WDNR Data Request Question #1:

Enbridge Response to WDNR Data Request Question #1

HDD

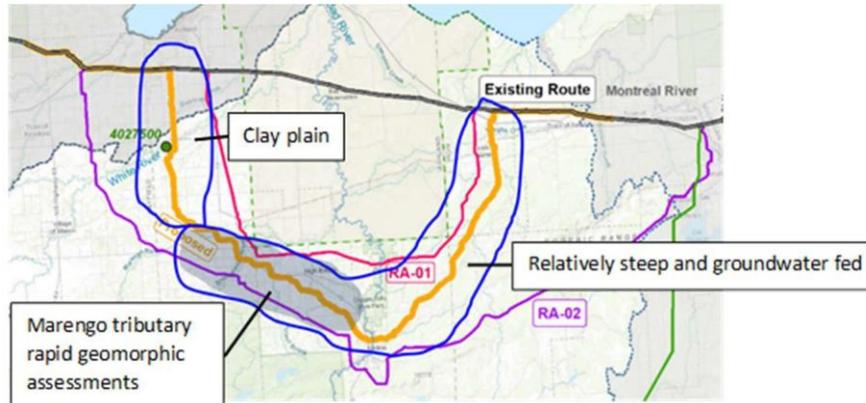
As discussed in previous Enbridge filings as well as above, Enbridge has internal construction standards that are used in conjunction with experience from specialized HDD design firms to develop site-specific plans for each HDD. Enbridge's designs incorporate and consider geotechnical information documenting subsurface geology, topography between the entry and exit locations as well as workspace for pipe fabrication, required depth below river bottom, pipe diameter and associated installation radius and drilling mud hydraulics. For this Project, Enbridge conducted preconstruction geotechnical investigations to design and confirm the suitability of the subsurface material for HDD. In concert with those carefully developed designs, Enbridge will use a highly experienced HDD company with years of experience successfully completing drills to help plan, design and execute each drill. These plans will include the requirements set forth in Wisconsin Technical Standard 1072 for Horizontal Directional Drilling. Enbridge further evaluated the designs and events of the recent Line 3 Replacement Project in Minnesota with its HDD design engineering firm to assess modifications to the Project designs to further reduce the likelihood of an IR. Enbridge made modifications to the Project HDD designs as appropriate. However, to be successful, an HDD operation requires large additional temporary workspaces at the drill entry and exit locations for staging and equipment. It also requires suitable subsurface geology conducive to drilling; relatively flat topography for pipe fabrication; and a relatively straight cleared area of ROW on the drill exit side to fabricate the pipe segments to be pulled back under the river.

An HDD crossing of this length or greater for narrow waterways is not warranted and may not be feasible without additional ROW area, and suitable topography and subsurface geology. Moreover, as described above, use of the HDD method could result in additional wetland and waterbody impacts due to the additional workspace required for drilling and pipe string fabrication. For small waterbodies, the additional impacts associated with an HDD could offset any environmental advantages in the utilization of HDD. Additionally, further use of the HDD method would result in extension of the Project construction schedule to accommodate the additional time required to complete an HDD, resulting in

longer disturbance to resources near the HDD locations that would remain disturbed until the HDDs could be completed.
